*Southern California Edison*  
**Moorpark-Newbury A.13-10-021**

**DATA REQUEST SET A1310021 Moorpark-Newbury-ED-SCE-03**

**Question Q.07:**

**Question Q.08:**

**Moorpark-Newbury 66kV Subtransmission Project:**  
 Map Developed in Response to CPUC Data Request Set ED-03, Question 9

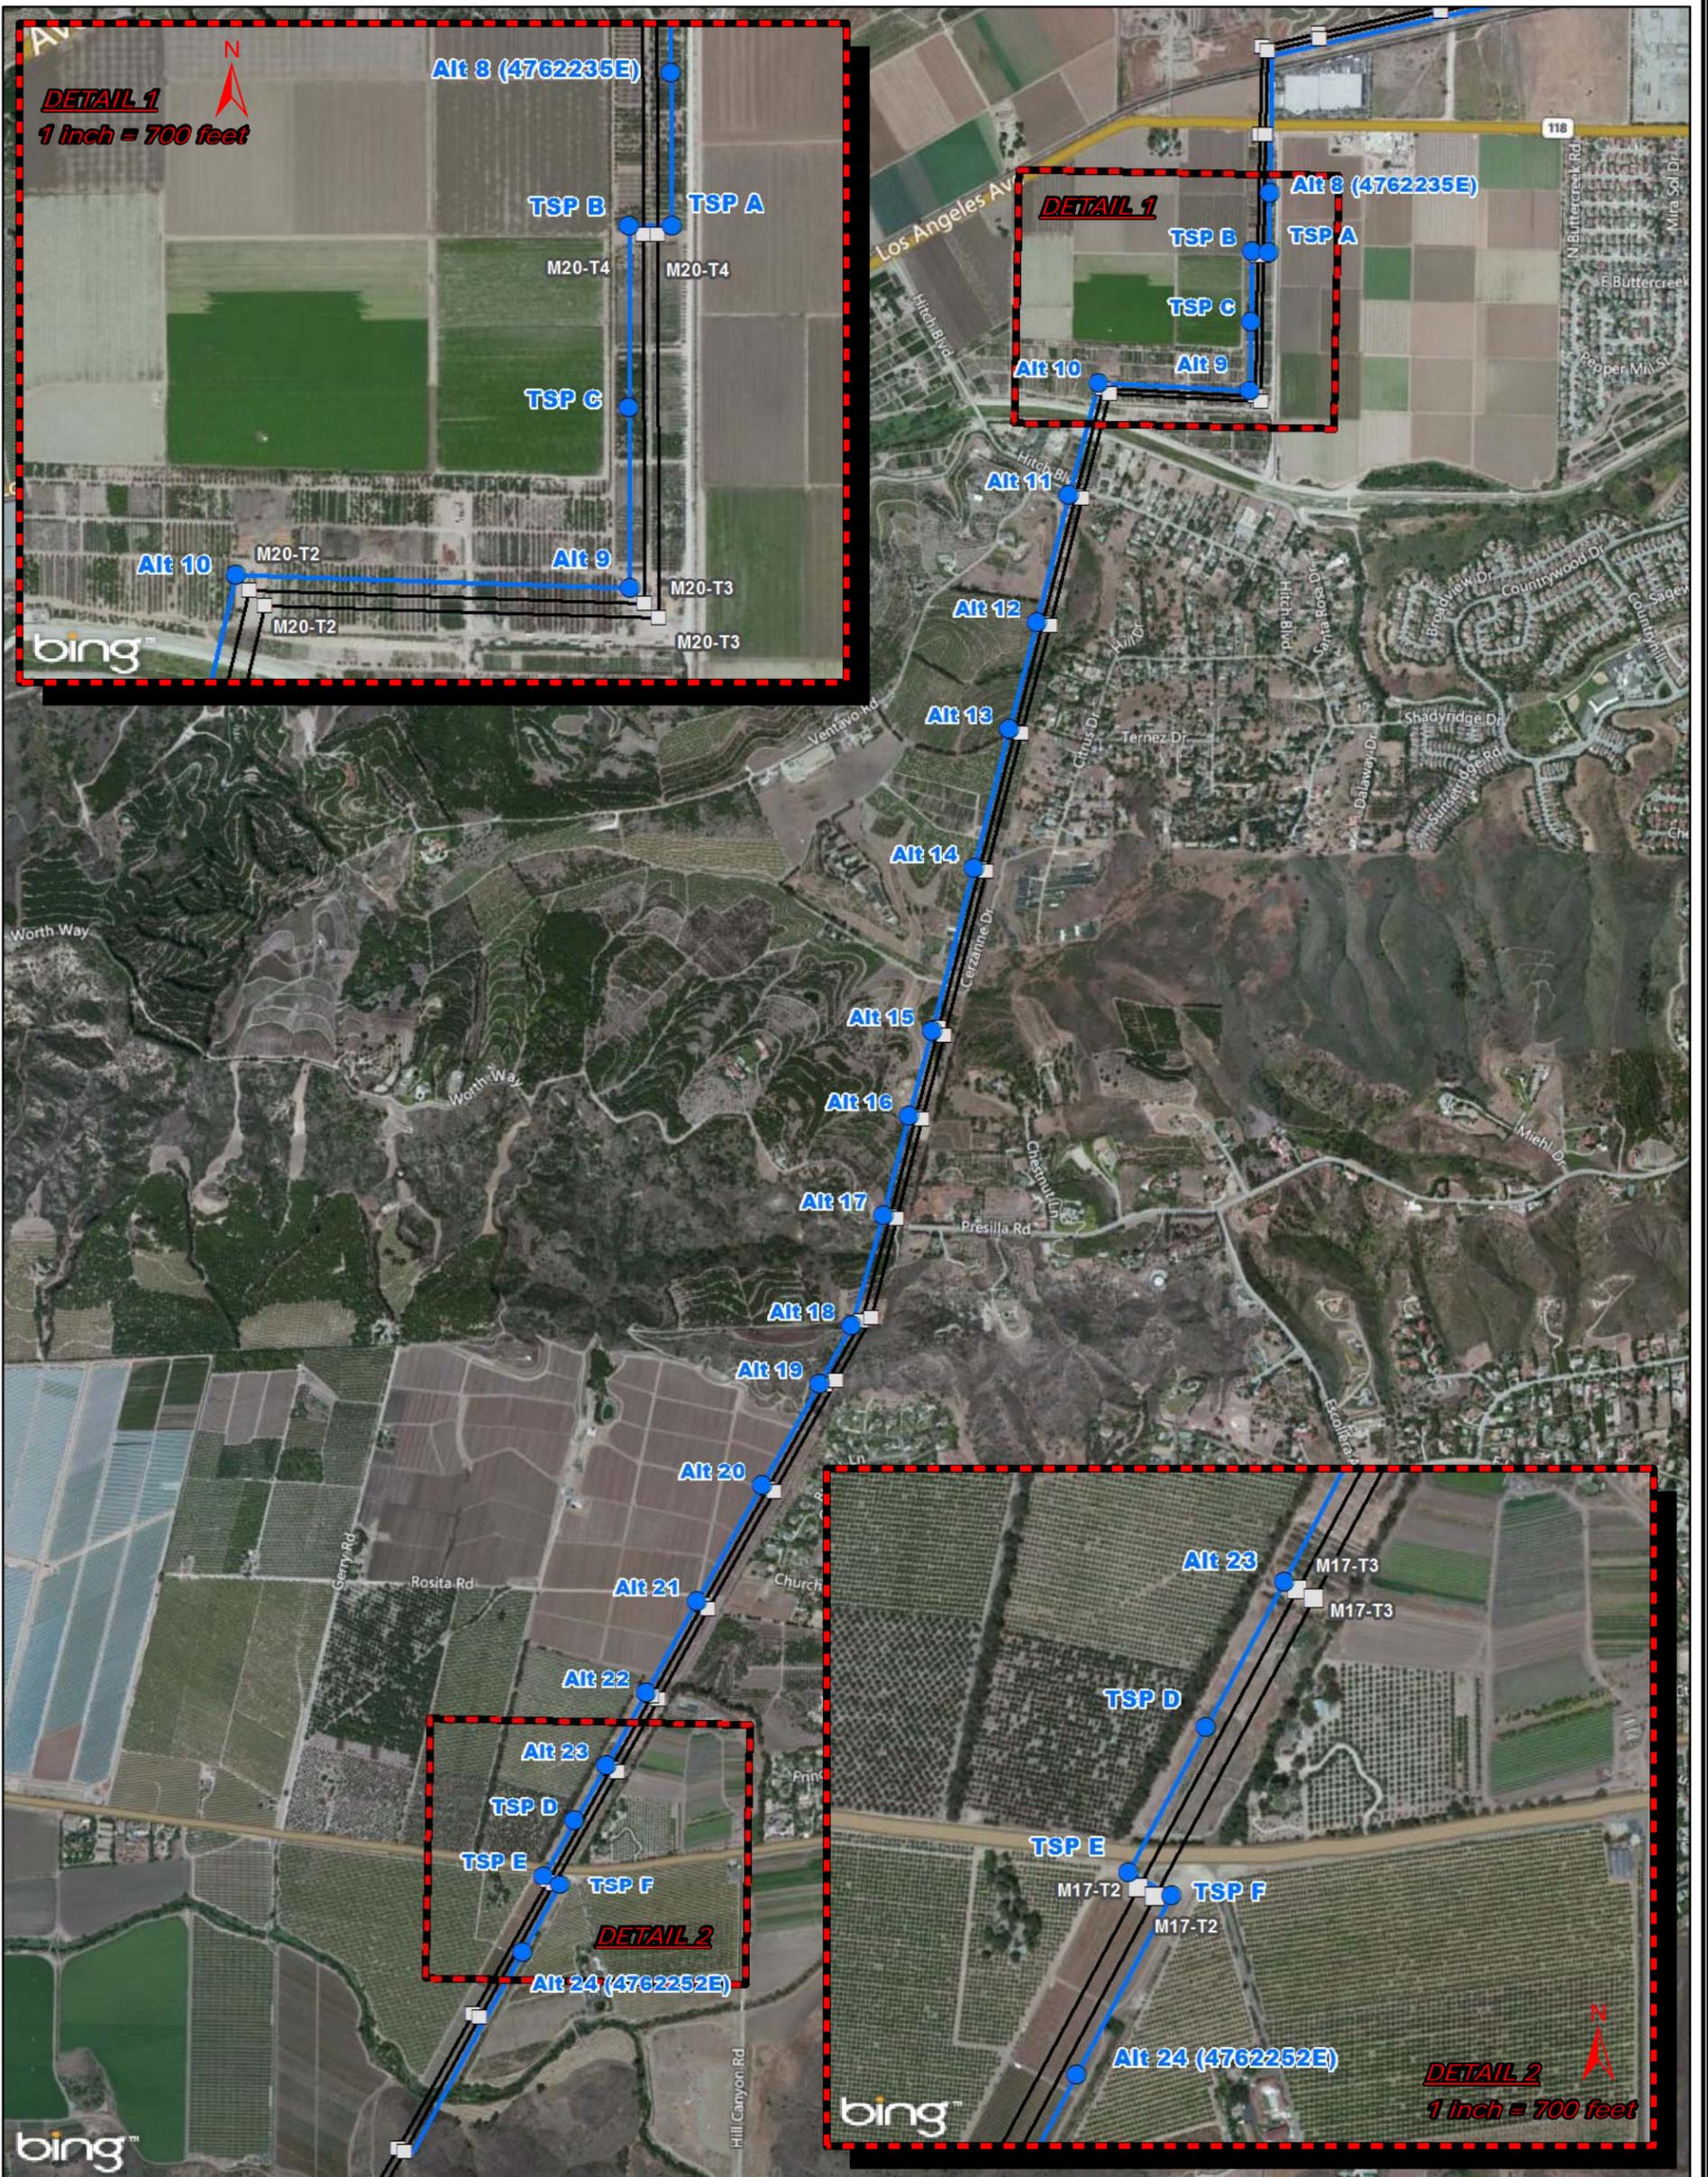
Regarding Subtransmission line Alternative 2, in SCE response to Proceeding Ludington Data Request 1, Question 8, SCE's cost estimates for the alternative assume replacement of four double-circuit 220 kV towers with taller towers in order to maintain required G.O. 95 clearances as necessitated by the installation of the 66 kV crossings of the 220 kV lines. Please provide drawings (indicating height and width) for each of the poles/towers (220 kV and 66 kV) that would be utilized in each of the crossings in order to maintain the required G.O. clearances. Also note any topographic or other physical features that influence the design. Please also provide an explanation why the proposed subtransmission line poles could not be sized in order to cross under the existing 220 kV poles.

In response to this Data Request question, SCE recently performed a detailed engineering review to analyze whether the 220 kV portal towers would require replacement as previously anticipated. The detailed engineering review determined that it would be feasible to cross under the existing 220 kV portal towers without having to replace the existing portal towers to meet GO 95 requirements (even though GO 95 Section III Rule 31.3, Conflicts and Crossings expressly states that crossings should be avoided unless absolutely necessary). In order to do so, SCE would need to add six new TSPs to the proposed Moorpark-Newbury 66 kV Subtransmission Line and move two previously installed TSPs, (Sites 8 and 24), north and south, respectively. The TSPs at Sites 8 and 24, as well as proposed new TSPs C and D would need to be interset in the existing alignment to prevent the new 66 kV line from swinging into the existing 220 kV lines. New TSPs A, B, E and F would facilitate the crossing.

- Data sheets indicating the heights and widths required for the six new TSPs (MOORPARK-NEWBURY XING DATA SHEETS REV B.PDF)
- Data sheets for the two existing TSPs that would be moved (M56773\_SH8-Model.pdf and M57663\_SH24-Model.pdf)
- Exhibit showing proposed crossing locations (MNP\_AlternativeOverview\_20150113.pdf)
